6.6 PLN16/0434 - 26 - 56 Queens Parade, Fitzroy North

1. On 2 December 2020 Council received notice of the applicant's intent to substitute amended plans for the application plans at the hearing scheduled to commence on 15 February 2021.
2. This report provides Council with assessment of the amended plans and is to be read in conjunction with the previous officer report.

6.6	PLN16/0434 - 26 - 56 Queens Parade, Fitzroy North
Reference	D20/166137
Author	Mary Osman - Manager Statutory Planning
Authoriser	Manager Statutory Planning
Ward:	Nicholls
Proposal:	<p>Proposed substituted plans. Pursuant to section 87A of the <i>Planning and Environment Act 1987</i> amend Planning Permit PLN16/0434 which allows:</p> <ul style="list-style-type: none"> • Construction of two or more dwellings on a lot in a 10 storey building plus two basements in the Mixed Use Zone under clause 32.04-6 • Use of part of the land for the sale and consumption of liquor (on premises) under clause 52.27 • Part demolition or removal of a building in a Heritage Overlay under clause 43.01-1 • Construction of a building or construction or carrying out works in a Heritage Overlay under clause 43.01-2 • Reduction of the ca

Figure 4 – Proposed Amended Fourth Floor Plan

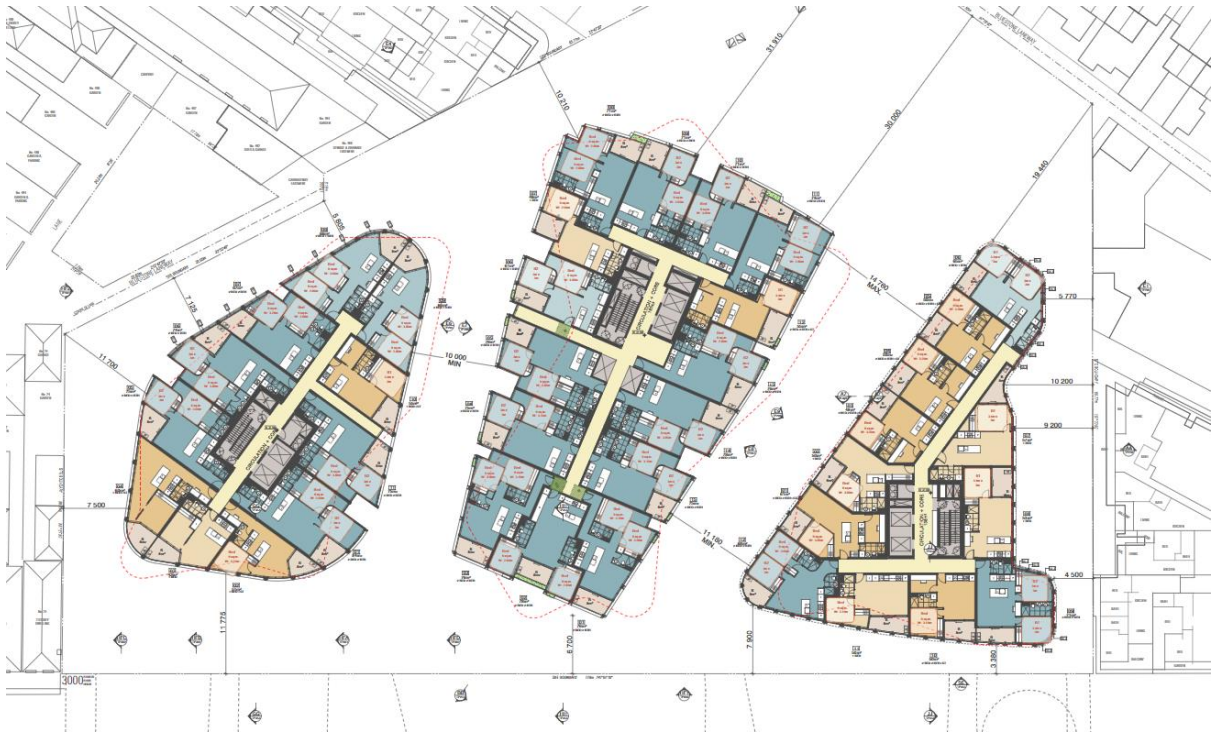
- (a) At fourth floor the three tower forms are clear of perimeter built form
- (b) Setbacks generally same as original application plans;

Figure 23 Original amendment application - Shadow at 10am

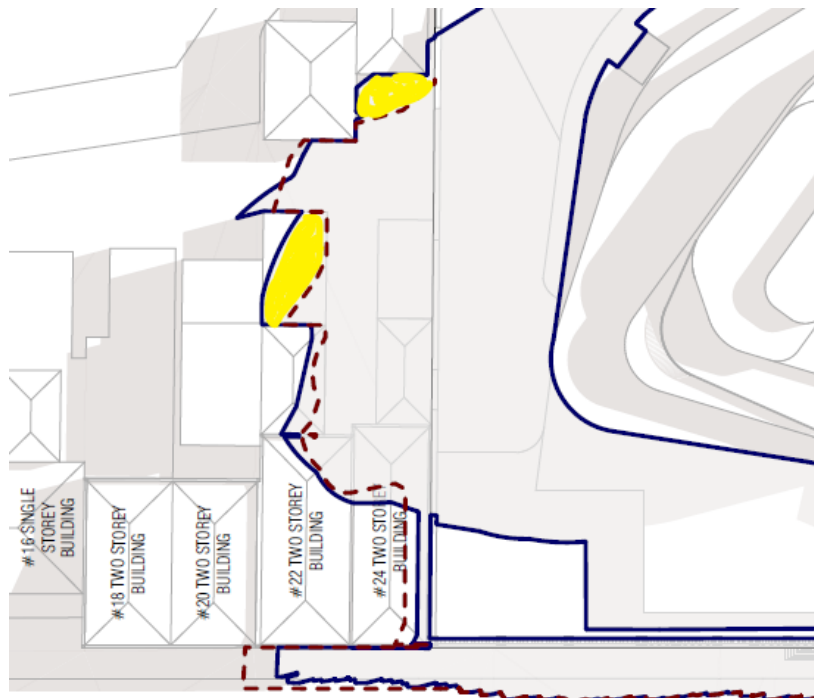
86. The shadowing impact as outlined in the previous officer report was limited to a concern regarding the properties at 22 and 24 Queens Parade at 10:00am. The affected area shown in yellow below.

Figure 24 Amendment application - Shadow at 10am

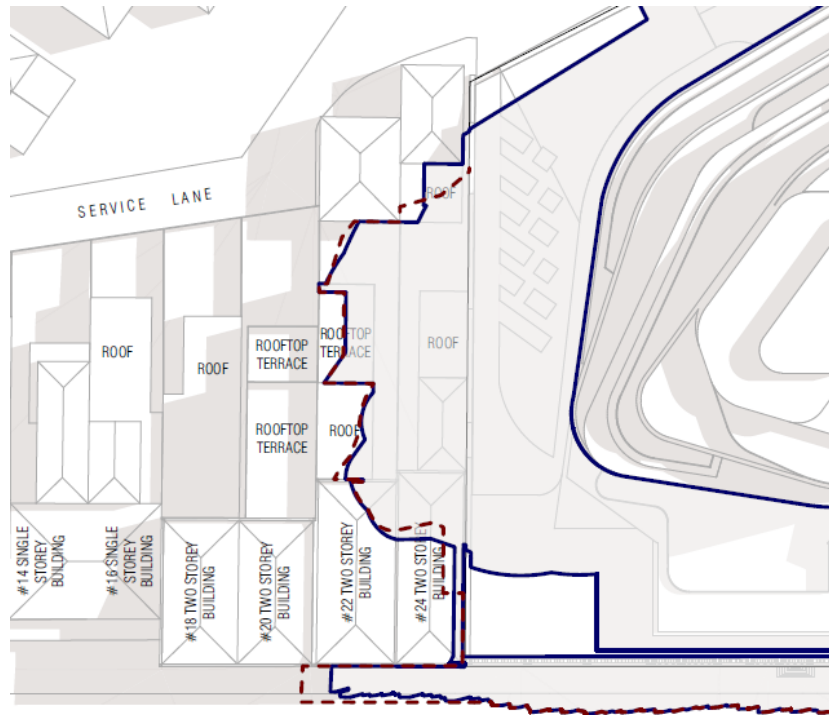
87. New shadow diagrams have been prepared which now show that shadows are generally consistent with the already approved scenario raising no further concern with shadowing impact.

88. Off site amenity impacts have been satisfactorily addressed satisfying this ground of refusal.

Figure 26 – Proposed Amendment Studio Type 1

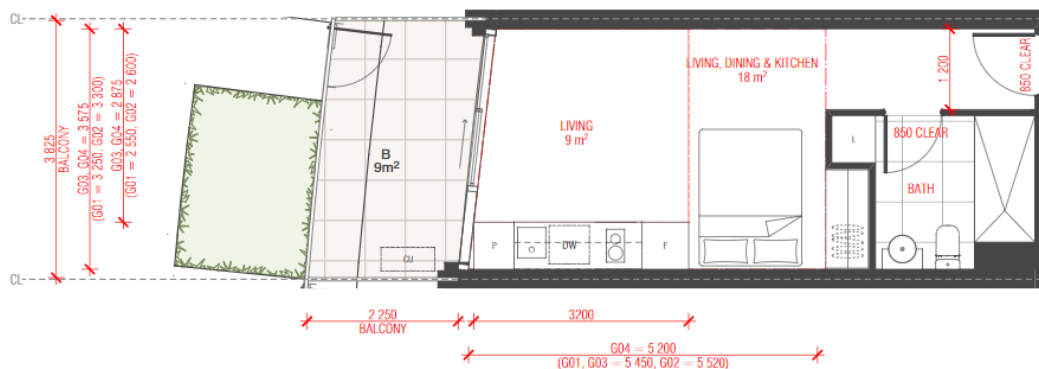
96. The amendment now seeks to 10 studio apartment layouts.
97. Council consultant urban designer Mr McGauran has maintained a position that these dwellings would offer a poor level amenity. However, an assessment of the studio types is prudent as some provide an acceptable level of amenity and therefore are a relevant typology that adds to the composition of apartment mixes offered by the development.

98. There are four Type 1 studio apartments located at ground floor of Tower 2 orientated to the north. This studio appears to be one of the smaller offering and the floors plans show that the 'living area' immediately abuts or overlaps the 'bedroom' area.

99. The amenity afforded to these four dwellings is not acceptable and they should be deleted. The deletion of these dwellings affords an opportunity to replace this floor area with ground level communal facility which would accord with the advice from MR McGauran who advocates for better connected communal space.
100. Studio type 5 and 6 have similar internal layout issues to those expressed for type 1, there are 10 such apartments and should be deleted with the floor area absorbed into the neighbouring dwellings.

Figure 28 - Proposed Amendment Studio Type 5 & 6

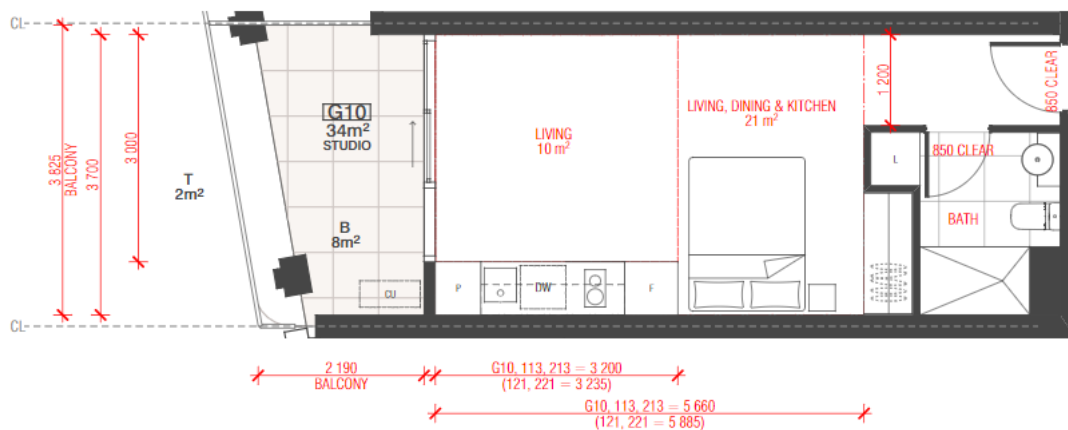
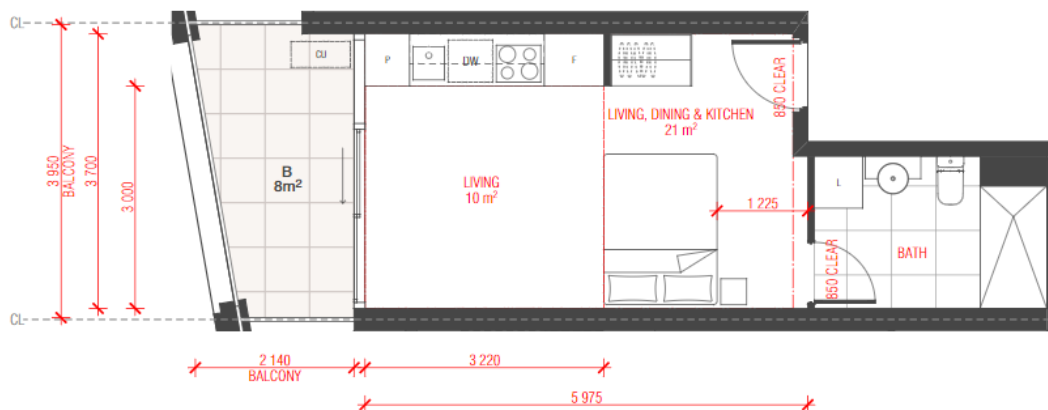
101. When assessing the functional layout of the dwellings, borrowing from clause 58, Living area dimensions (excluding dining and kitchen areas) should have a minimum width of 3.3m and a minimum area of 10sqm for a Studio or one bedroom dwelling and minimum width of 3.6m and minimum area of 12sqm of two or more bedrooms. The proposed layouts show the minimum square metres has generally been provided across the units.

Figure 31 – Proposed Amendment Level 1

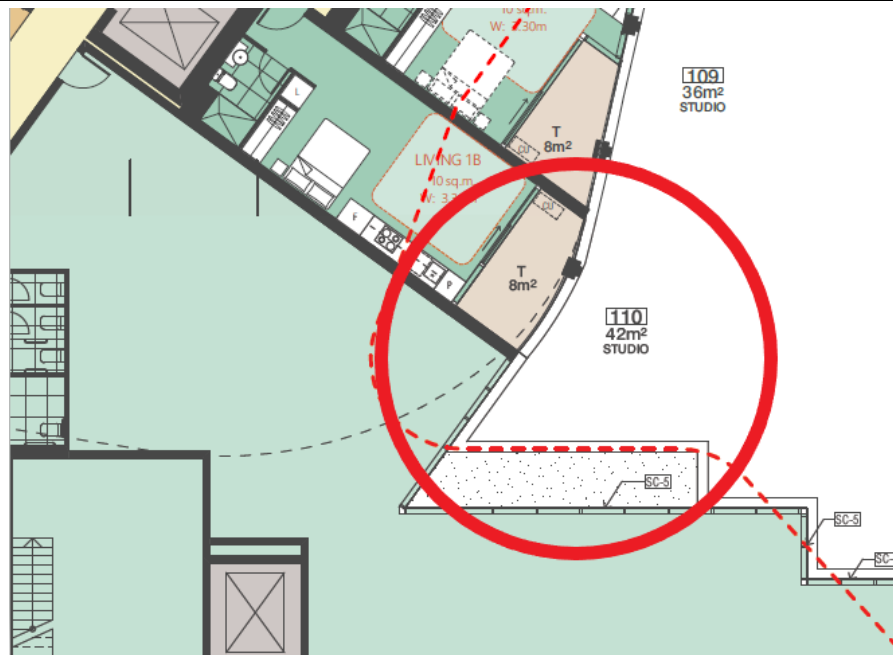
- 113. At the elbow where Towers 2 & 3 meet creates a pinch point between apartments (Towers 2 & 3) 109 & 115 and 209 and 215.
- 114. The plans detail that apartments 115 and 215 will have the northern elevation screened with fritted glass which while providing screening to this interface also allows for daylight into the bedrooms.
- 115. As outlined previously outlined and subject to the confirmation that all habitable spaces including bedrooms meet best practice for daylight, this outcome is considered to be acceptable.

Figure 32 - Proposed Amendment Basement 1 Plan

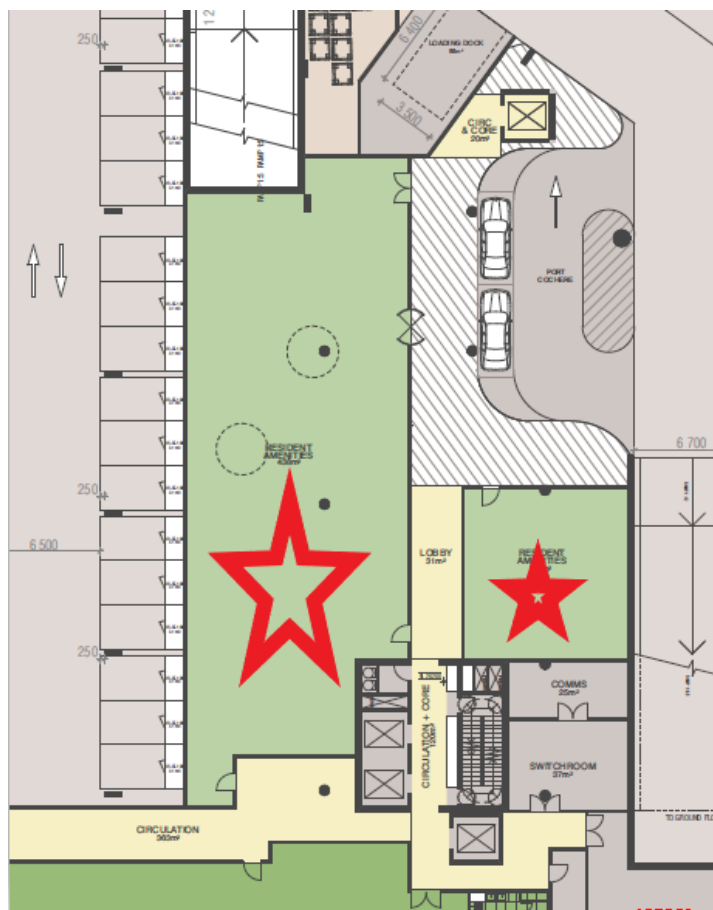
116. The plans continue to show two areas of resident amenities located in Basement 1. No information regarding how these spaces will fitted out as has been provided however is anticipated that these space would be use as yoga room, library, dining, gaming type spaces as outlined in the submitted acoustic report. These space have no access to daylight other than two skylights as shown in the figure below.

117. Concerns regarding the lack of daylight and natural ventilation have not been addressed. A condition as discussed earlier requires the deletion of 4 studio apartments adjacent to the northern pavilion. By providing a second communal amenities area above ground and further supplemented by the amenities and communal outdoor space at level 8 Tower 1 the proposal is considered to be acceptable.

Figure 35 – Original Application Mr McGauran Ground Floor Mark Ups

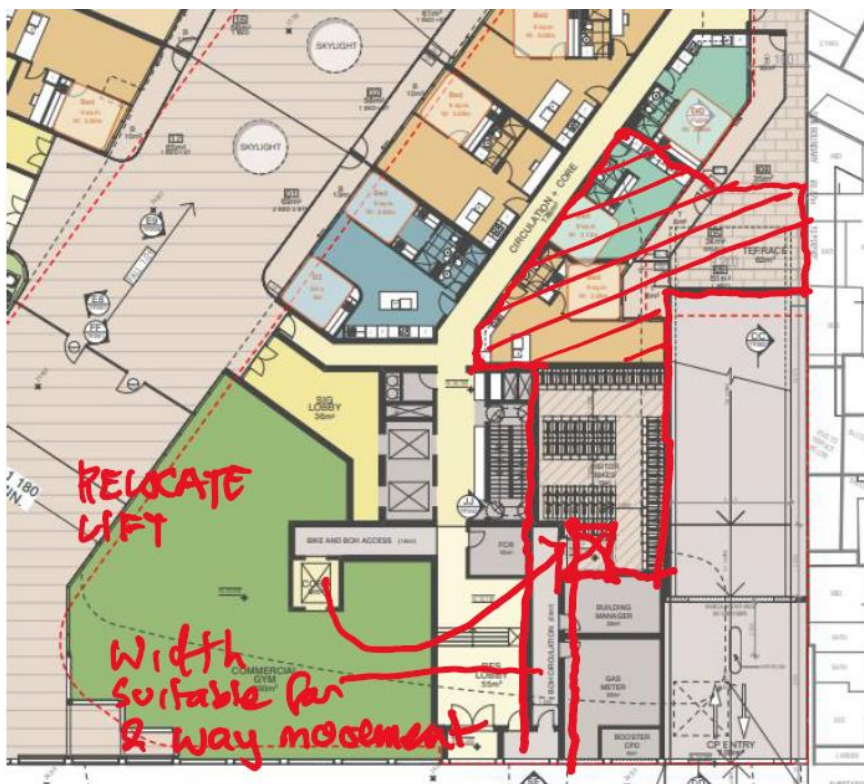
- (b) Expand ground level bicycle storage and relocate a substantial amount of basement level 2 bicycle storage to ground level and basement 2 level storage to basement level 1;

Figure 39 – Proposed Amended Basement 2 Plan

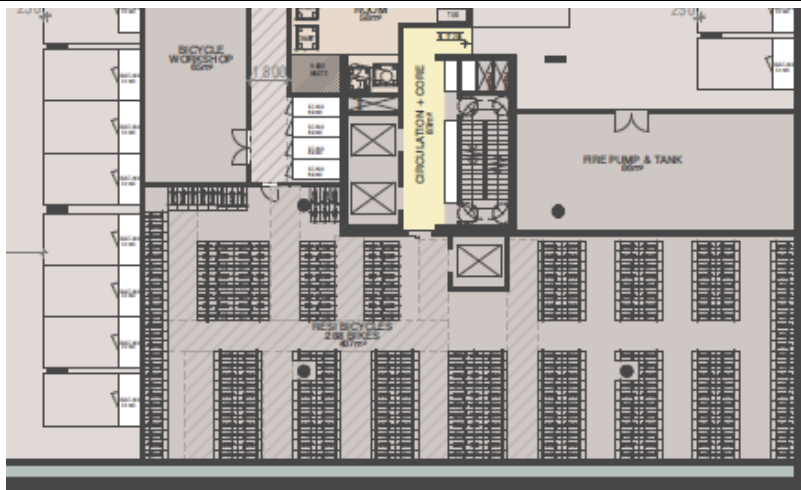
167. The second bike parking area has not been moved to basement 1 as suggested by Council's consultant urban designer, however the layout and design has been improved to better facilitate access.
